WHANGANUI DISTRICT COUNCIL

Subject: **Section 42a Officers Report**
**Proposed Plan Change 44 – Network Utilities, Parking,
Loading and Vehicle Crossings**

Prepared for Chief Executive by: **Rachael Pull**

Electricity transmission yard (shown in red) means:

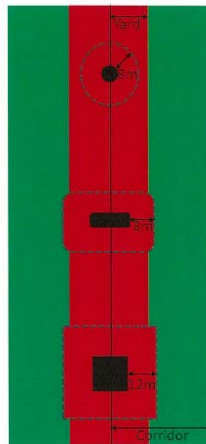
- The definitions of '**Electricity transmission yard**' and '**Electricity transmission corridor**' are to be deleted and replaced with 'National Grid Yard' and 'National Grid Subdivision Corridor'. This will give effect to the NPSET and provide clarity to Plan users. This is the current terminology that will be used for these areas. When the rest of the zones are reviewed, these are the terms that will be used. Therefore, rather than have two sets of terminology across the Plan, it is reasonable to update now during the network utility review.

- The area located 12 metres in any direction from the outside visible edge of an electricity transmission support structure; and
- The area located 10 metres either side of the centreline of a 110kV electricity transmission line on poles; or
- The area located 12 metres either side of the centreline of a 110kV electricity line on pi poles or towers.
